Service Bulletin

S.B. No: 179

Title: INSPECTION OF TAILPLANE ATTACHMENT BRACKETS

CHANGES INCORPORATED BY THIS ISSUE 4:

FIGURE 1

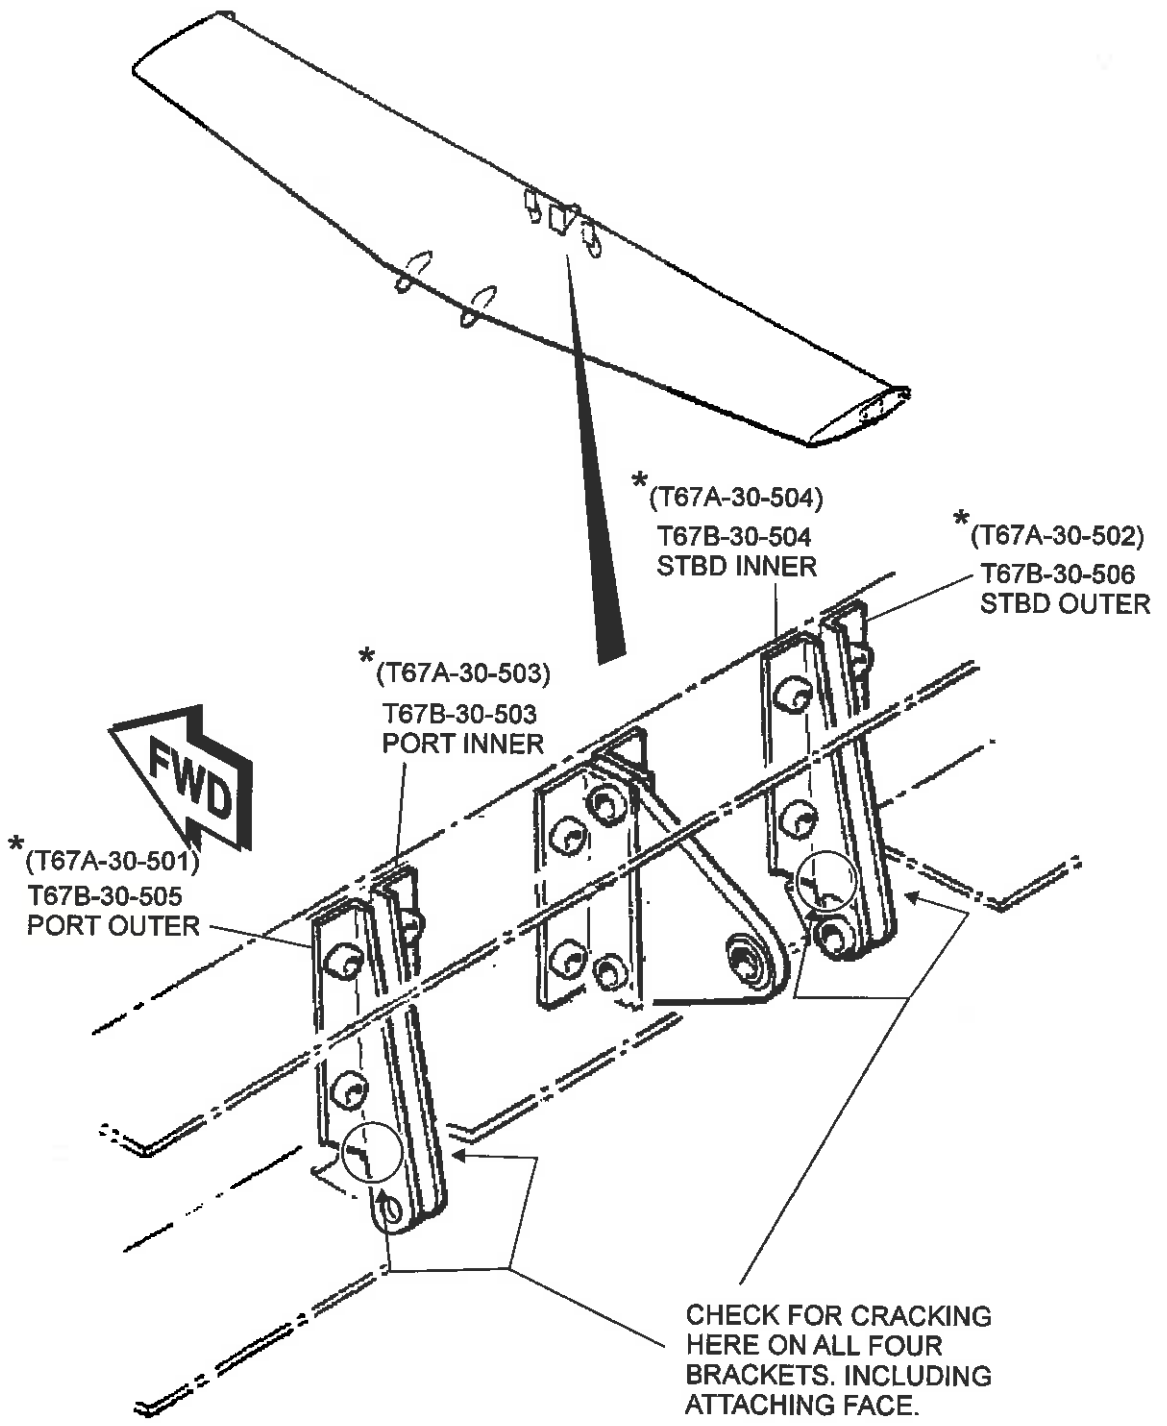
Cases have been reported of cracked in aluminium tailplane mounted attachment brackets – see Figure 1. This Service Bulletin details inspection of the aft tailplane brackets in order to discover similar cracks.

3. Remove paint from bracket.
4. Perform dye penetrant (or similar) NDT crack detection on brackets and examine, paying particular attention to the region illustrated in Figure 1.
5. Should any crack be discovered, all four tailplane-mounted brackets from the subject aircraft shall be returned to SACL for investigation and disposal and new Pre Mod M988A or B, or Post Mod M988A or B brackets are to be fitted.

FIGURE 2

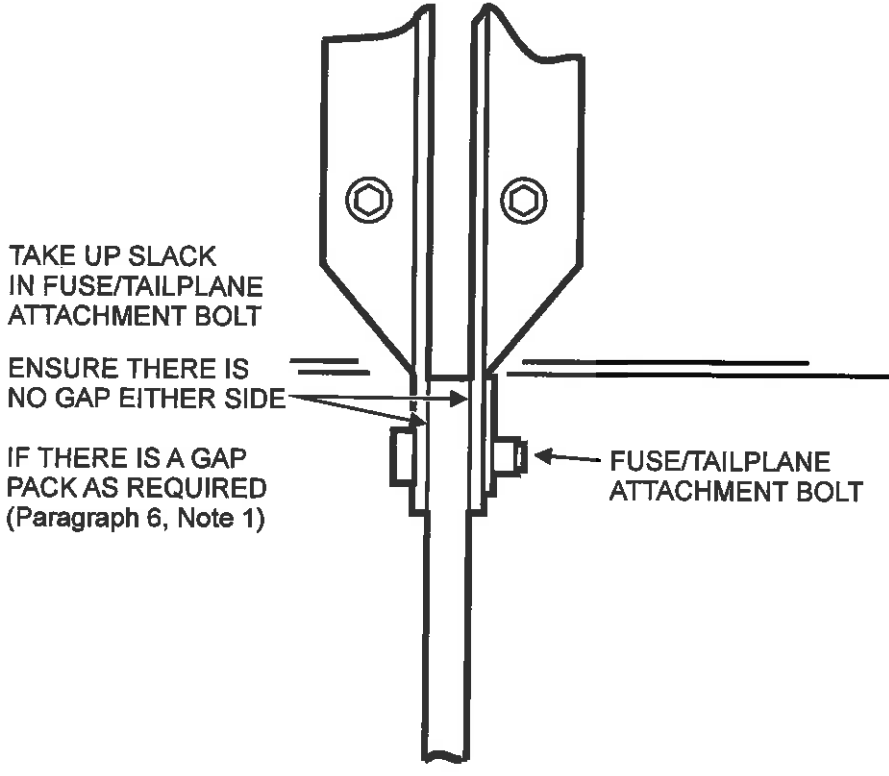
Tailplane brackets are to be re-fitted to tailplane "finger tight" initially. Then using a .25 inch (6.35mm) wide gap setting tool or tailplane attachment bracket T67B-11-521, to ascertain if there is going to be an additional gap. If gap apparent, establish the dimension and fit requisite washers following guidelines set out in Notes 1 and 2. When satisfied tighten attachment bracket bolts, against gap setting tool and requisite washers as applicable. Remove gap setting tool and re-fit tailplane to fuselage with/without washers as previously established. Torque main fuselage to tailplane fuselage bolts to 60 lbf in.

NOTE 1 Prior to torquing main bolts; ensure there is either no gap or a gap of up to a maximum of .010" (.25mm) between fittings. If a gap greater than .010" (.25mm) does exist after taking up slack then it is permissible to fit washers as follows:

Washer/s of thicknesses; 0.016" (.4mm) (SACL Stores Code 126-23-763), or 0.018" (.46mm) (SACL Stores Code 126-23-754), or 0.032" (.81mm) (SACL Stores Code 126-23-750). Thinning of 0.032" washer is acceptable providing faces of washer remain parallel. Re-protect modified face, use Duralac or similar anti-fretting compound.
